**PROPOSED MANUFACTURING FACILITY AND ASSOCIATED CAR PARKING AND
LANDSCAPING, IPSEN BIOPHARM, WREXHAM INDUSTRIAL ESTATE
PLANNING APPLICATION REFERENCE P/2023/0482**

MEMORANDUM

Land at Ash Road North, Wrexham Industrial Estate, LL13 9JT Construction of manufacturing facility and associated car parking and landscaping

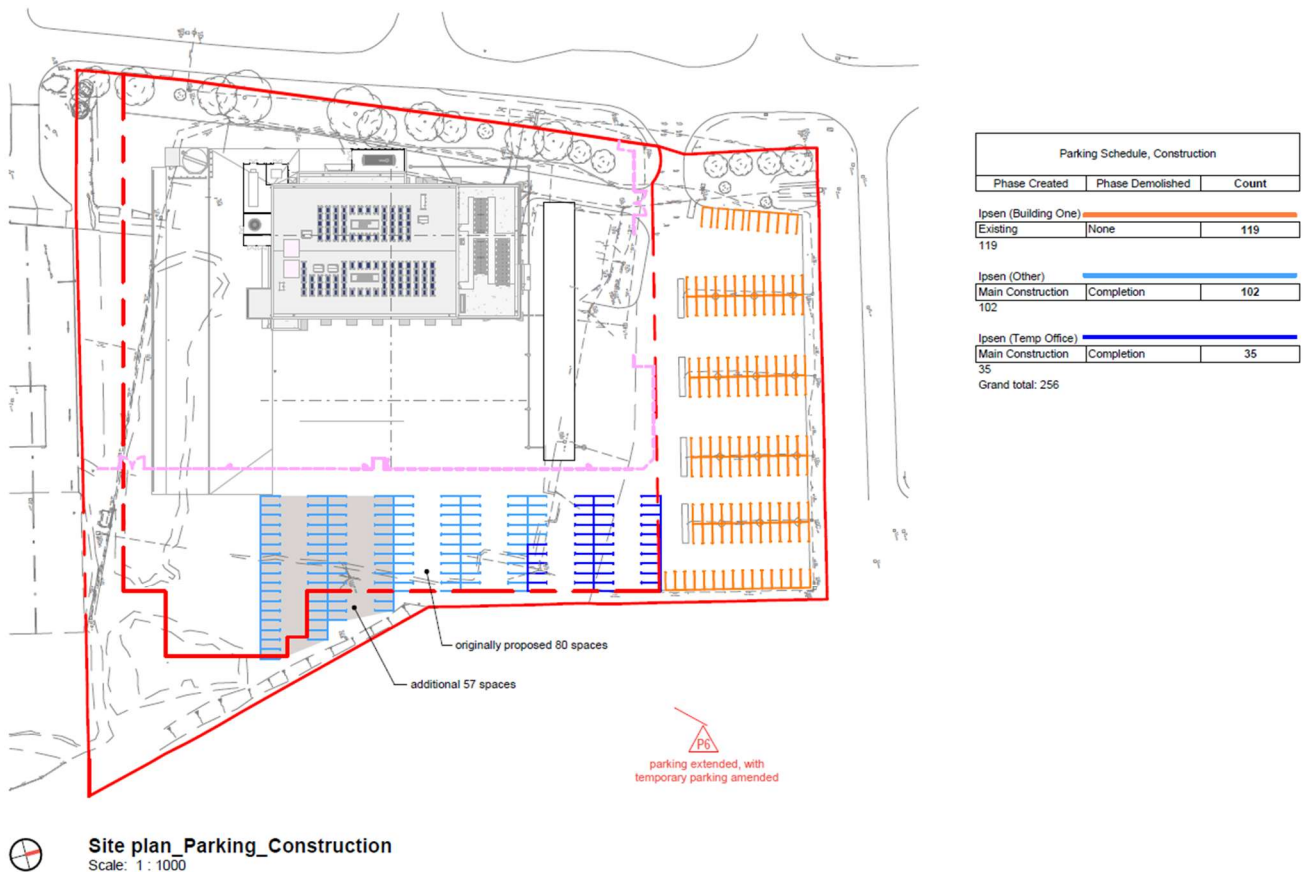
Comments: *“A parking phasing plan showing parking arrangements during the construction period and how parking will be phased with the temporary office building.”*

The sketch below shows how the temporary parking layout would work during the construction. A total of 256 spaces would be retained at all times, in advance of the Proposed NDP Building being completed, at which stage the parking layout on the drawing enclosed with this letter would be available for use.

During construction, all contractor parking demand and laydown areas will be provided for within the pink dashed hoarding line shown on the sketch below, therefore contractors will not need any of the surrounding 256 spaces, which would remain open for Ipsen staff to utilise.

3402-01-ATR01

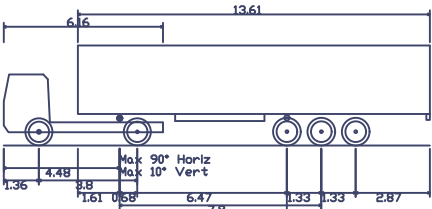
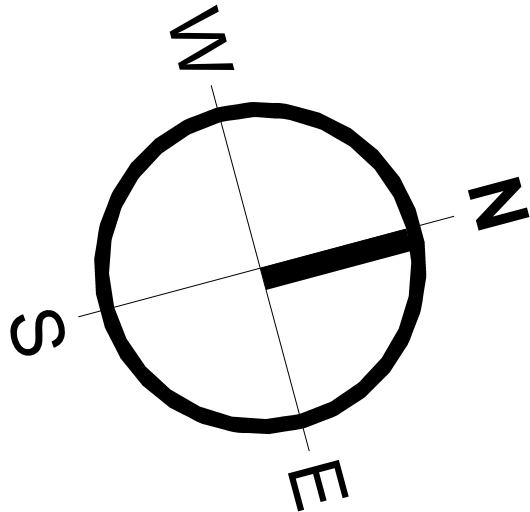
Comments: ***“A revised site access arrangement to accommodate two-way vehicle movements. Tracking should be provided to evidence two-way movements can be achieved.”***

Comments: *“A visibility splay for the site access junction in accordance with TAN18.”*

Nonetheless, to address the LHA's comments, a minor scheme of widening is now proposed at the site access, as shown on the revised **drawing number 3402-01-ATR01 Rev B**, enclosed with this letter. The widening can be achieved internally within the site red-line boundary and private land ownership of the Applicant, without affecting the adopted highway.

With the proposed minor scheme of widening in place, the drawing demonstrates that a car would be able to satisfactorily pass an articulated bulk tanker vehicle at the site access.

Drawing number 3402-01-ATR01 Rev B, enclosed with this letter, demonstrates that 2.4m x 120m junction visibility splays are achievable from the site access, which is commensurate with the highway standards contained in TAN18 for a 40mph road (as per the speed limit on Ash Road North).

LMA Project		Drawing number						Rev.	
Project	Originator	Zone	Level	Type	Rev	DrawingNumber			
2227	IED	LMA	XX	XX	DR	A	9516	P6

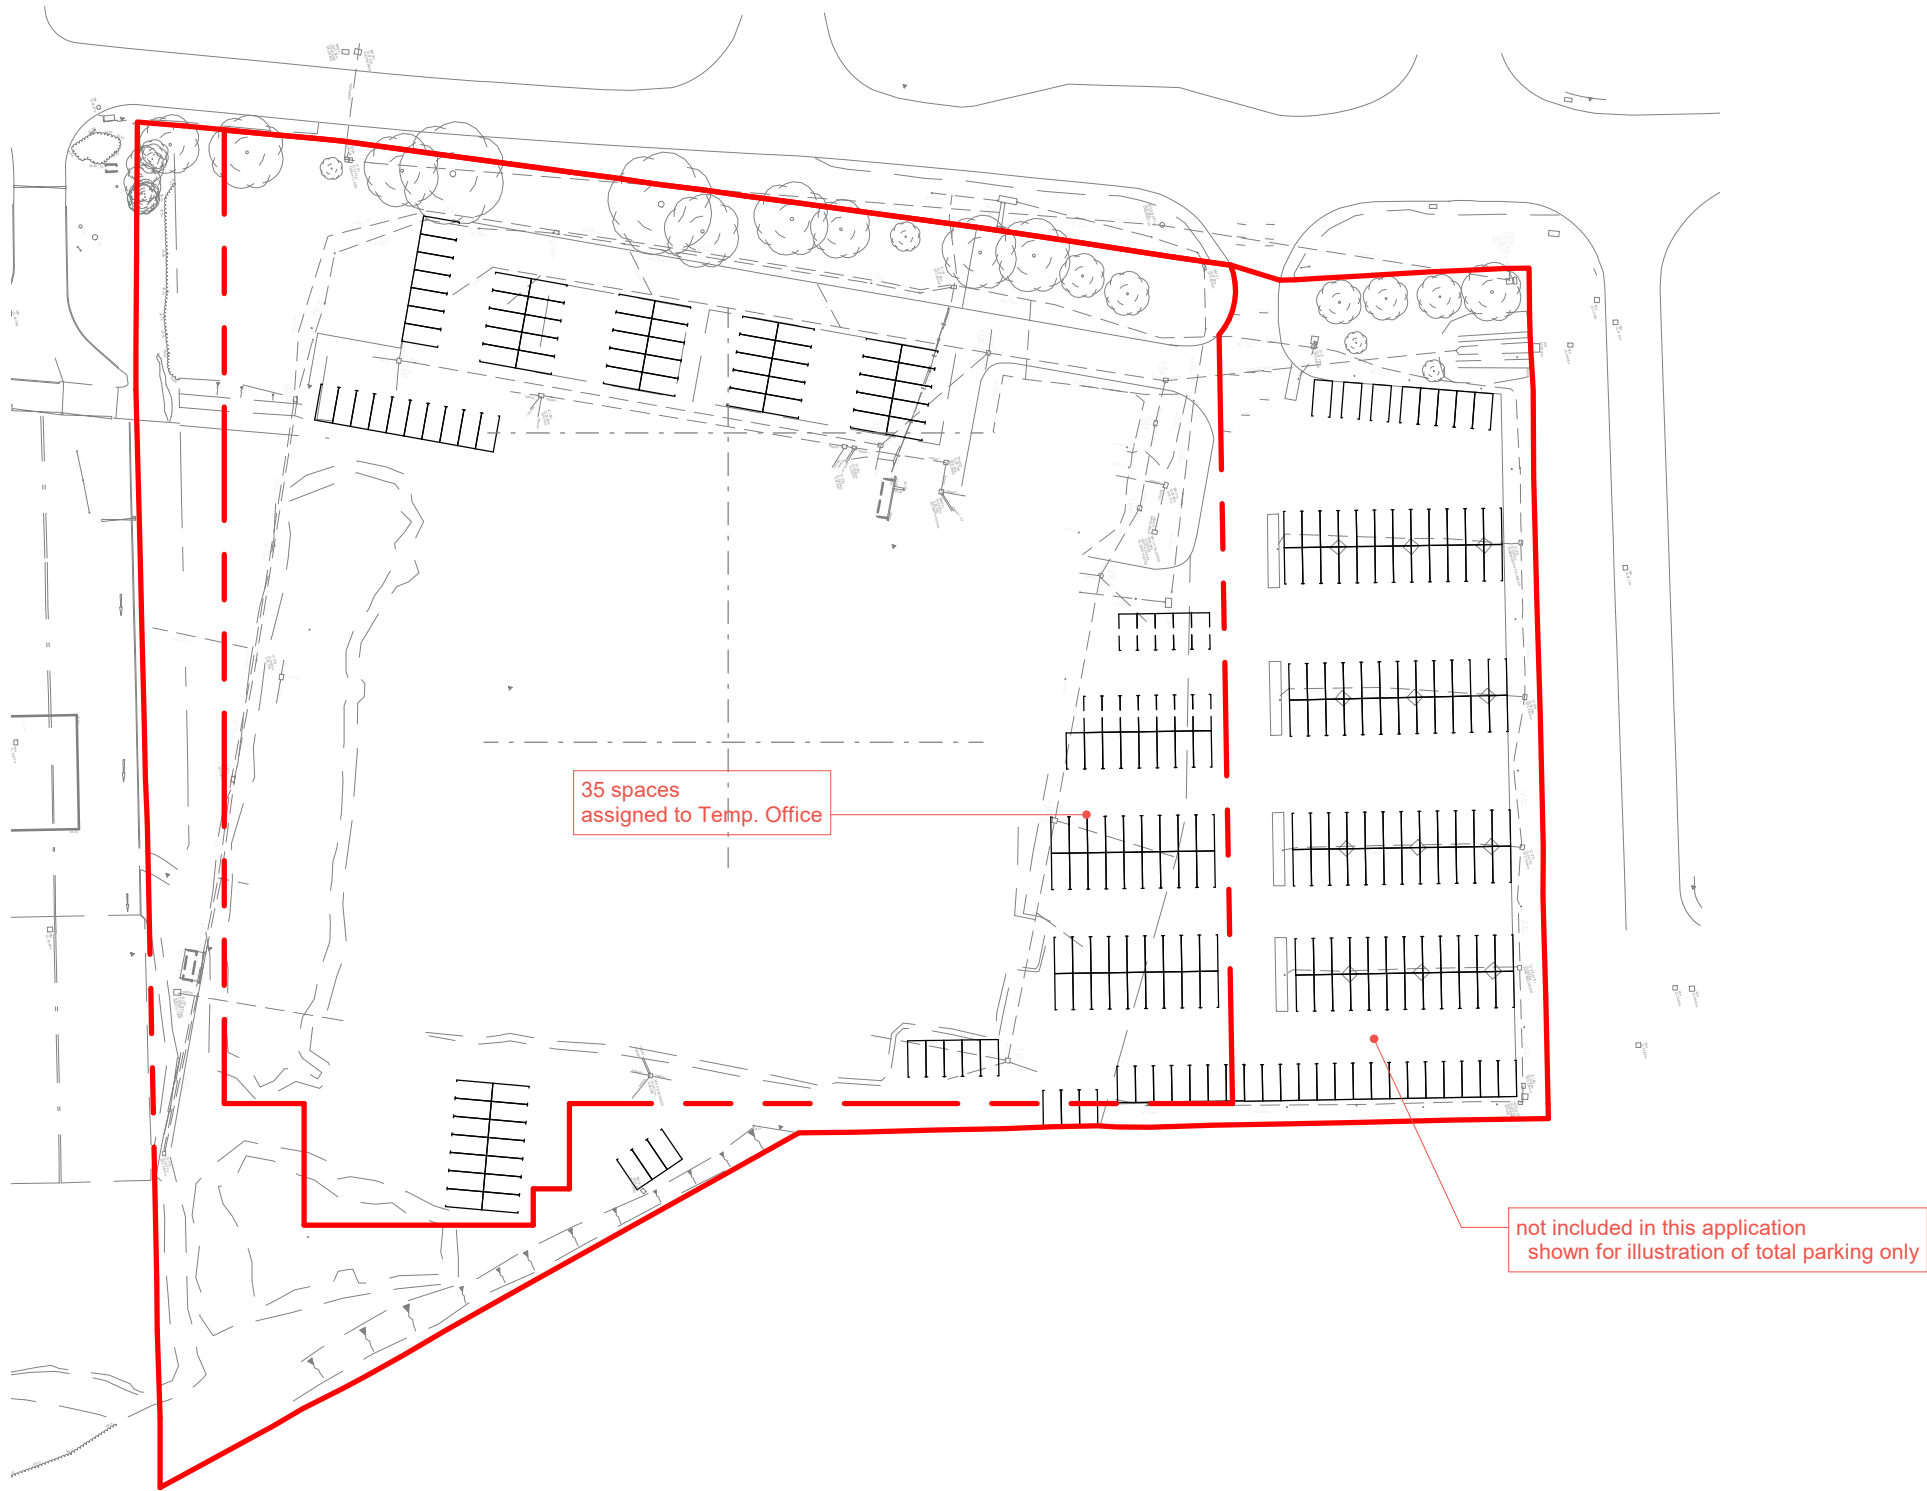
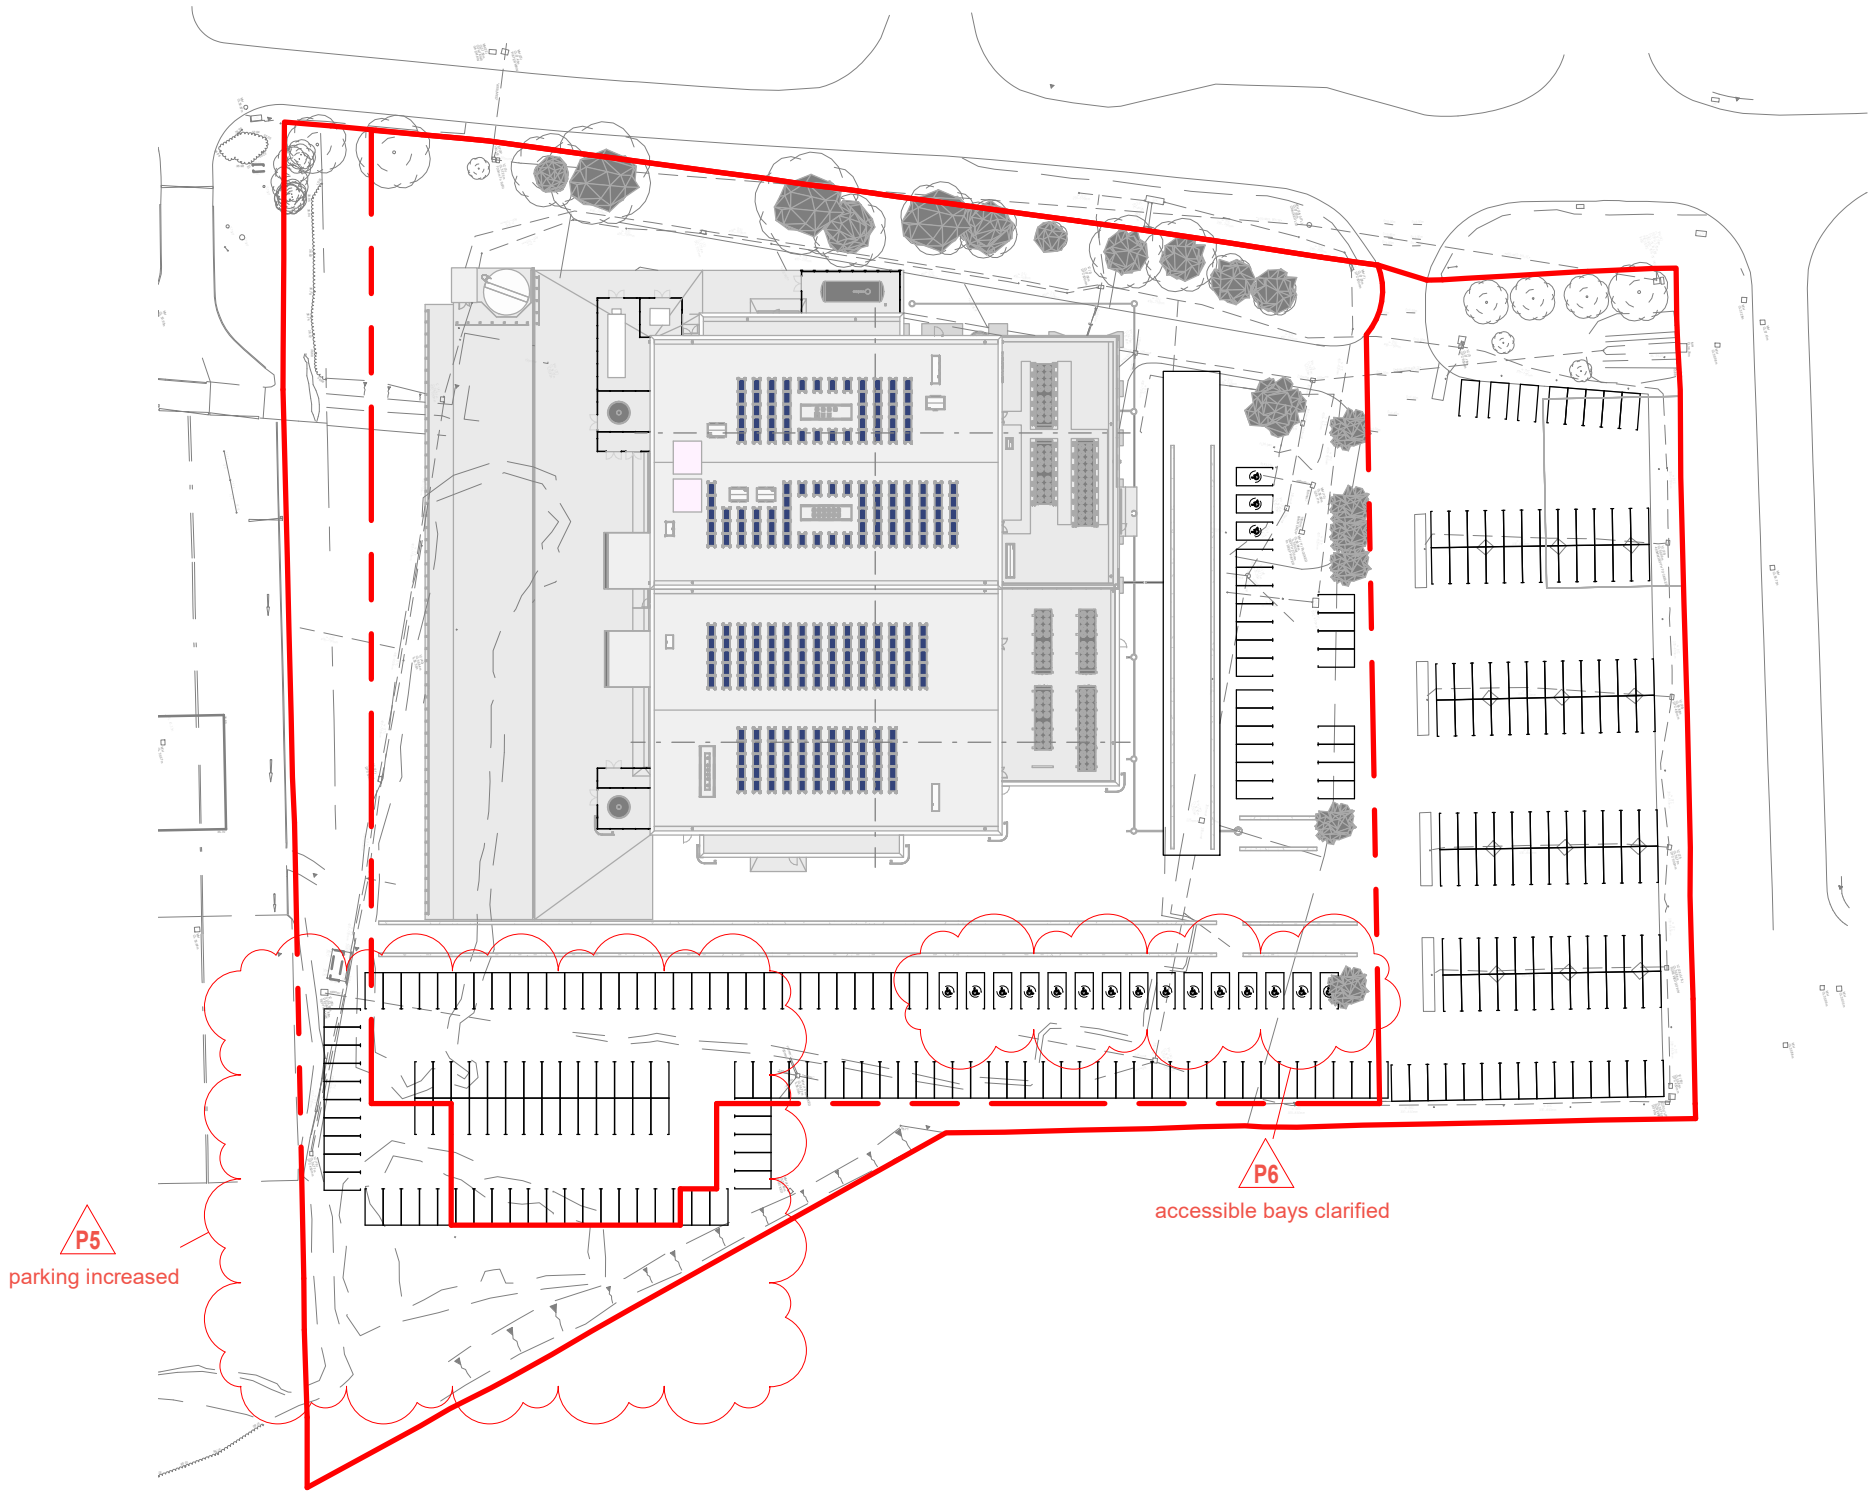
Comments: *“Evidence the existing number of car parking spaces will be sufficient to meet future demand and how the 24 lost spaces will be accommodated.”*

Comments: “Clarification on the number and location of accessible car parking spaces.”

In order to address this issue in an expedient manner, the proposed site layout plan has been revised to include an additional 24 overflow parking spaces (making 288 in overall total), which have been added in the south-eastern corner of the overall site. This is shown on the revised site layout plan (**drawing number 2227 IED LMA XX XX DR A 9516 Rev P6**, enclosed with this letter).

Technically, the LPG16 requirement for the provision of 10% accessible bays should only apply to those new spaces that are to be added for the Proposed Development (i.e. 10% of 24 = 3 spaces). These are shown on the revised site layout plan (**drawing number 2227 IED LMA XX XX DR A 9516 Rev P6** enclosed with this letter).

Notwithstanding this, the revised site layout plan also demonstrates that, as part of the reorganisation of the existing 145 spaces within the red-line boundary, 15 further accessible standard bays will also be added, to effectively retrospectively improve provision for those existing Ipsen staff members who need it.
